DEPARTMENT OF THE AIR FORCE
HEADQUARTERS, UNITED STATES AIR FORCE TECHNICAL ORDER
WASHINGTON 31R2-4-18-502

MODIFICATION OF HAMMARLUND COMMUNICATION RECEIVER
MODEL SP-600-JX-17 TO INCREASE OPERATIONAL EFFICIENCY

2. MODIFICATION DATA. (Globecom ECP #520-24)

Figure 1. Location of IF Gain Label and Card Holder

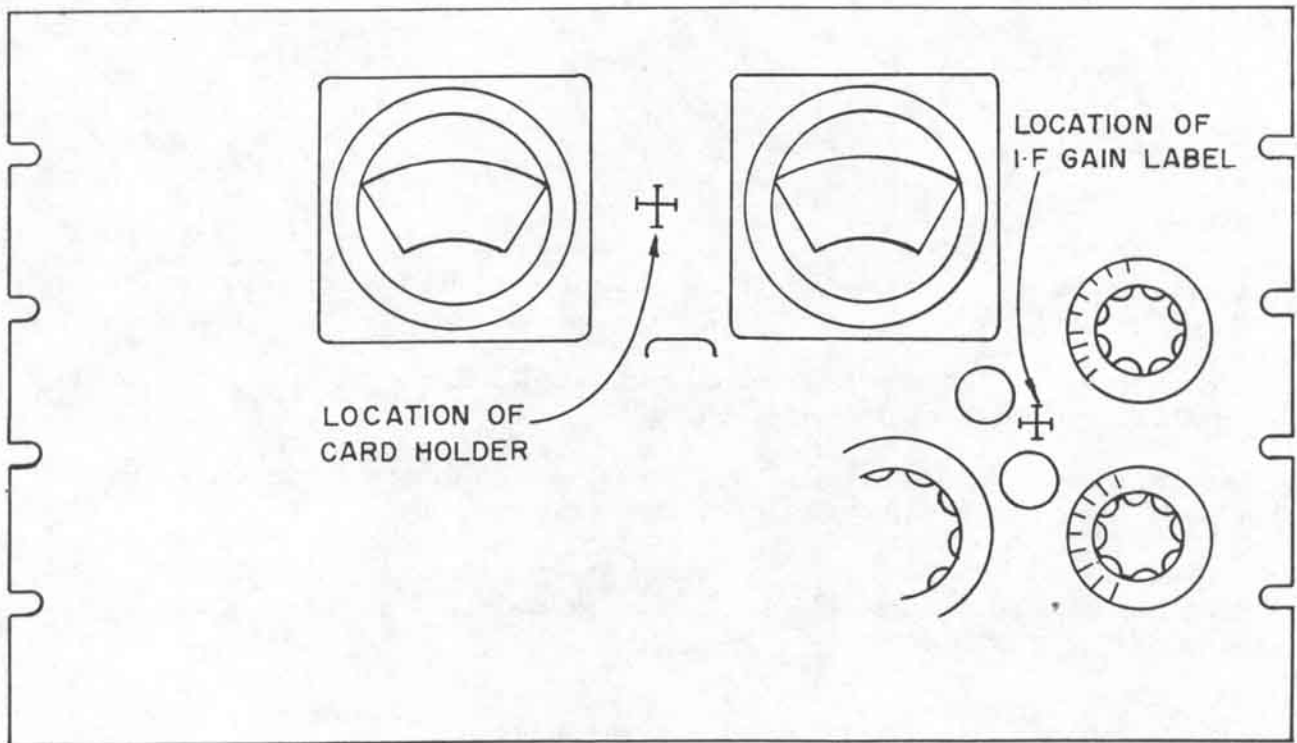
b. Addition of IF Gain label and card-holder to the front panel (see Figure 1).

(2) Remove dial lock knob and assembly, retaining the knob, nut and lockwasher for later use with new IF Gain control.

- (3) Place the receiver on its back with the front panel up, in horizontal position.
- (4) Clean the panel surfaces between dial escutcheons and around lettering of dial tuning lock, using an approved cleaning solvent such as trichloroethylene.
- (5) Apply a coating of toluol, supplied in capsule form in the kit, to rear surfaces of IF Gain label and card holder.
- (6) Wait about 30 seconds or until surfaces are tacky, then place the IF Gain label centered over the dial tuning lock lettering, and the card holder centered between the dial escutcheons. Apply even pressure to both labels and allow the adhesive material to harden.

Figure 2. Installation of IF Gain Control

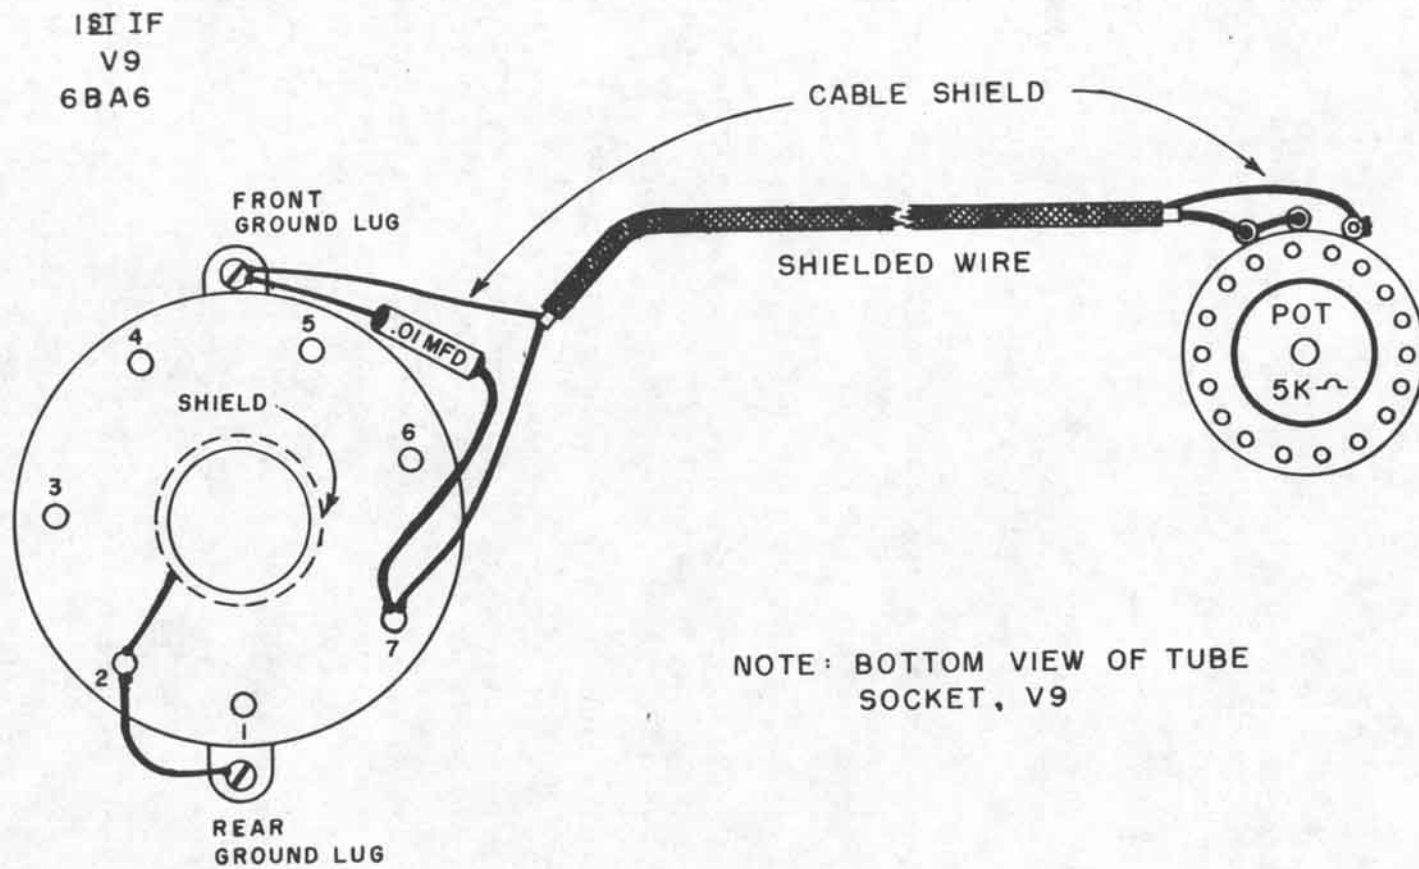
- (8) Replace tuning unit bottom cover.
- (9) Unsolder and remove wire connections between pin 7 and center-shield of socket for tube V9 and the chassis.

- (10) Connect pin 2 and center shield of socket for tube V9 to the rear ground lug of this socket (see Figure 2).
- (11) Connect the center conductor of new cable together with one lead of new 0.01 mfd capacitor to pin 7 of socket for tube V9 (see Figure 2).

- (12) Connect other lead of the new capacitor and cable shield to the front ground lug of the socket for tube V9 (see Figure 2).

Figure 3. Schematic Diagram of Modification to IF Stage

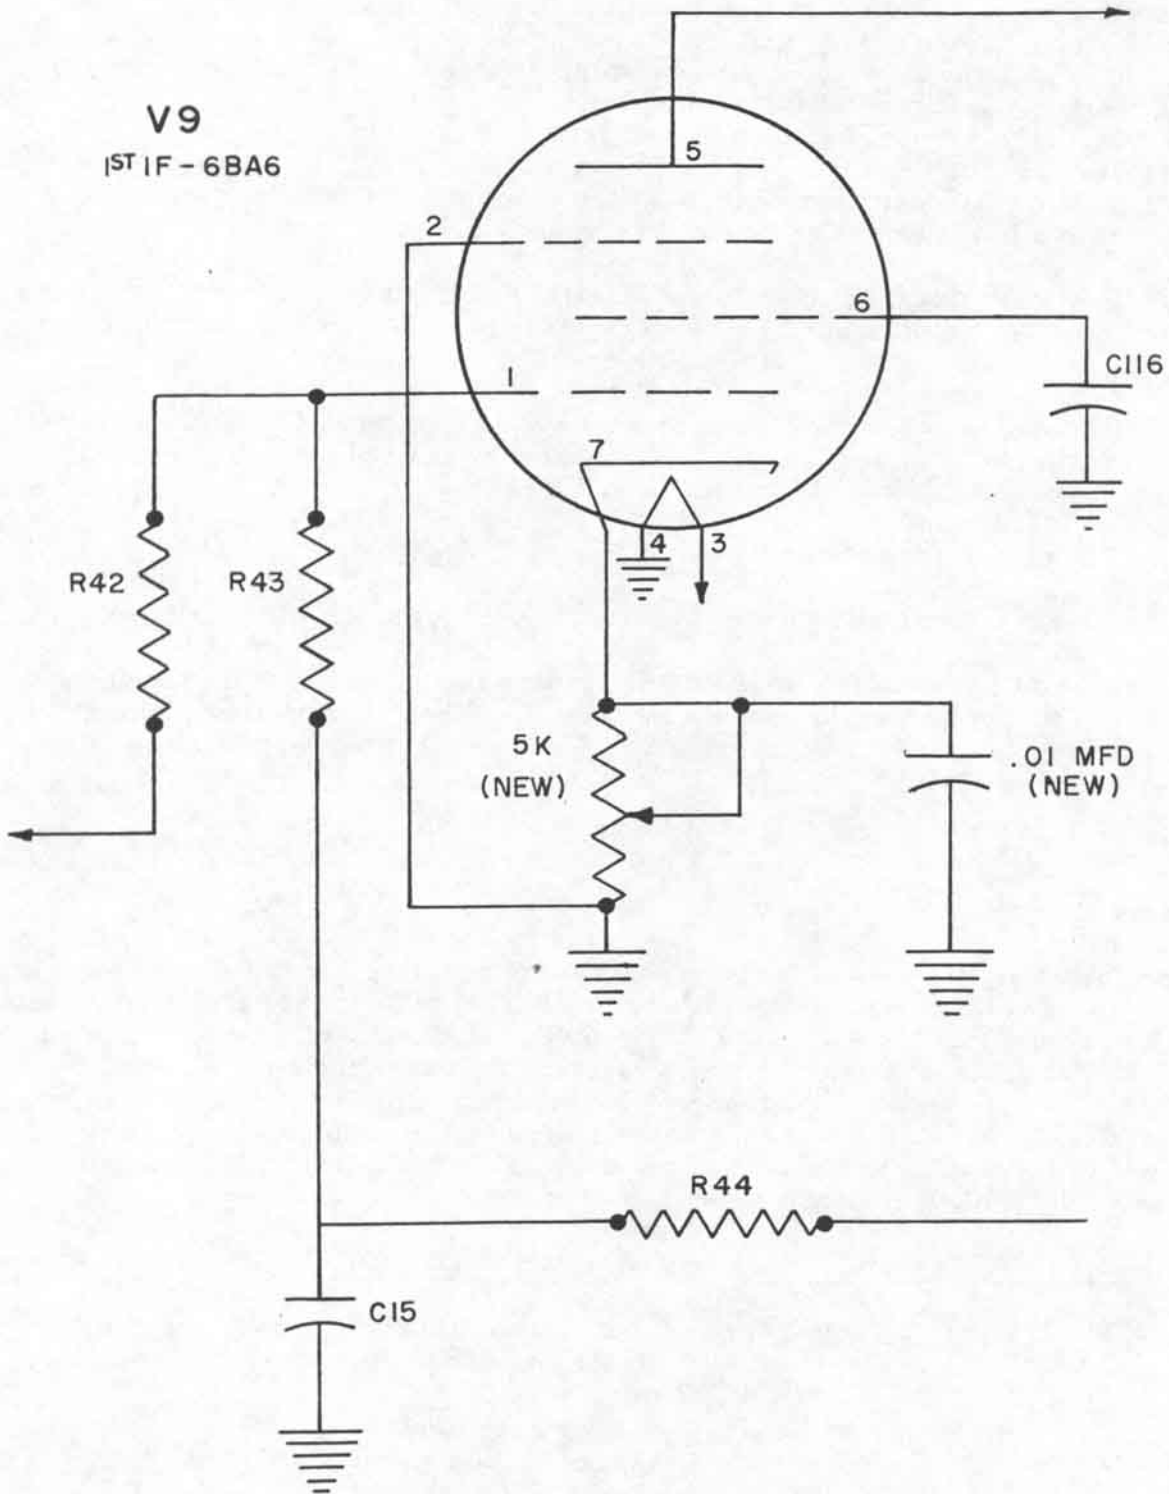
(14) Check the modification against Figure 3.
